COMMONWEALTH OF KENTUCKY
BEFORE THE PUBLIC SERVICE COMMISSION

ELECTRONIC JOINT APPLICATION OF)	
KENTUCKY UTILITIES COMPANY AND)	
LOUISVILLE GAS AND ELECTRIC)	
COMPANY FOR CERTIFICATES OF)	CASE NO. 2022-00402
PUBLIC CONVENIENCE AND NECESSITY)	
AND APPROVAL OF A DEMAND SIDE)	
MANAGEMENT PLAN)

RESPONSE OF
KENTUCKY UTILITIES COMPANY
AND
LOUISVILLE GAS AND ELECTRIC COMPANY
TO
THE METROPOLITAN HOUSING COALITION, KENTUCKIANS FOR THE
COMMONWEALTH, KENTUCKY SOLAR ENERGY SOCIETY AND
MOUNTAIN ASSOCIATION'S
SUPPLEMENTAL REQUEST FOR INFORMATION
DATED APRIL 14, 2023

FILED: MAY 4, 2023

Figure 1 – Weather Year Energy Requirements and Peak Demands⁷

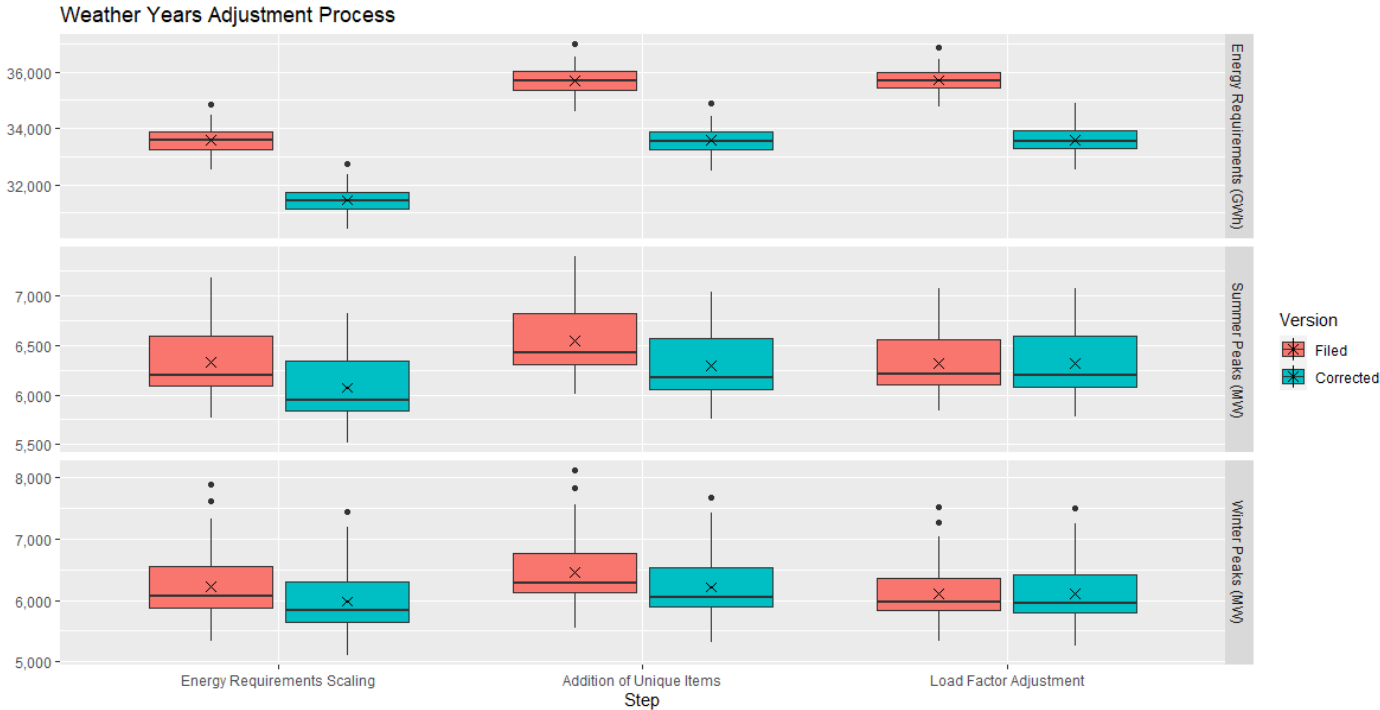
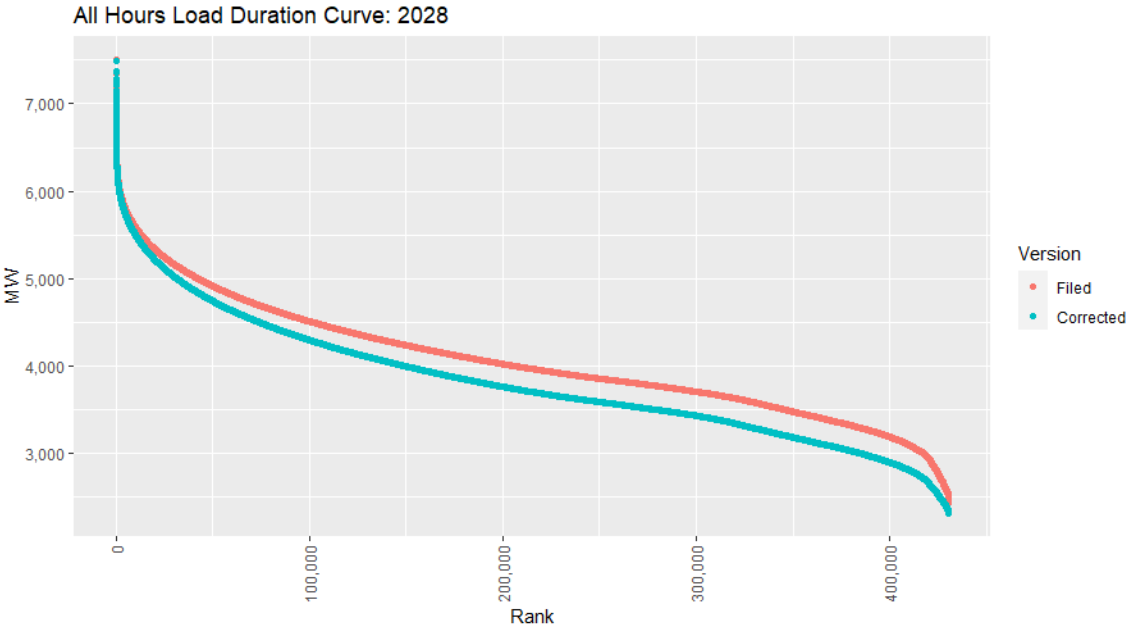
Figure 1 compares the original and corrected ranges of peak demands and energy requirements at key steps in the weather years process. After scaling the initial weather year forecasts to equal CPCN energy requirements that exclude unique forecast items, the corrected ranges of peak demands and energy requirements are lower than the original (see “Energy Requirements Scaling” step in Figure 1). For both the original and corrected ranges, the impact of layering on the unique forecast items is the same (see “Addition of Unique Items” step in Figure 1). Finally, because of the double counting, the seasonal load factor adjustments in the original weather year forecasts are greater than in the corrected forecasts (see “Load Factor Adjustment” step in Figure 1). As a result, the corrected distributions of summer and winter peak demands are not materially different from the originals, but the corrected distribution of energy requirements is approximately 5.8% lower. Figure 2 contains the filed and corrected load duration curves for all weather years and further demonstrates that the impact of this correction is greater in non-peak hours.
